MEMORANDUM

From:	Chief Officer, Environment & Technical	To:	Chief Officer Planning & Regulatory
		FAO::	Matthew Phillips
Our Ref:	ET/DC/MZ/P/2023/0050	Your Ref:	P/2023/0050
Date:	13 th August 2024

DATBLYGIAD PRESWYL O 96 ANNEDD AC ISADEILEDD CYSYLLTIEDIG / RESIDENTIAL DEVELOPMENT OF 96 NO. DWELLINGS AND ASSOCIATED INFRASTRUCTURE

LAND AT STANSTY FIELDS MOLD ROAD WREXHAM

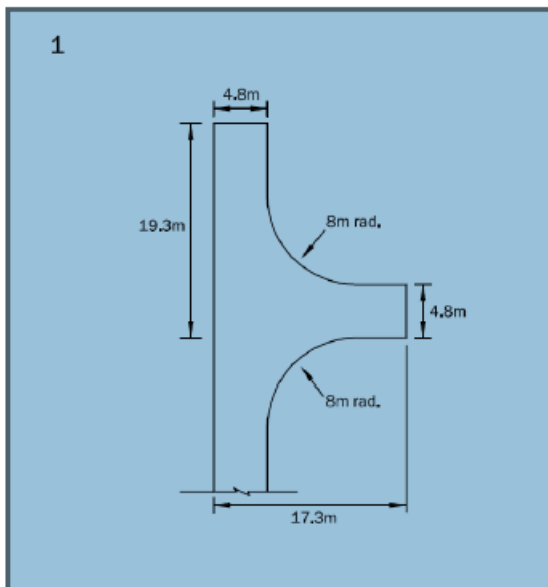
The proposed site access is onto Mold Road, at the point of the proposed site access it is a 50mph classified road with a central reservation and a dual two carriageway with a shared footway and cycleway along the eastern side. It is effectively one-way on the nearside carriageway. As such the visibility splay is only required looking to the right side out of the site. The visibility splay shown is 120m to the nearside kerbline from a point 4.5m back, for a 50mph speed limit, DMRB states that a visibility splay of (desirably) 9m x 160m is required.

It could be advisable to look to reduce the speed limit to 40 mph within the vicinity of the site access, no mention is made of this in the submitted Transportation Statement, however the residential areas to the north of the site are currently 40mph and it would seem consistent to extend this further past the proposed site entrance.

The required amendments to lining and signing and the required Traffic Regulation Order would need to be undertaken at the cost of the developer.

Updated plans are required to demonstrate this and it is considered that road safety audits stage 1,2 and 3 are required to assess the design of the proposed junction.
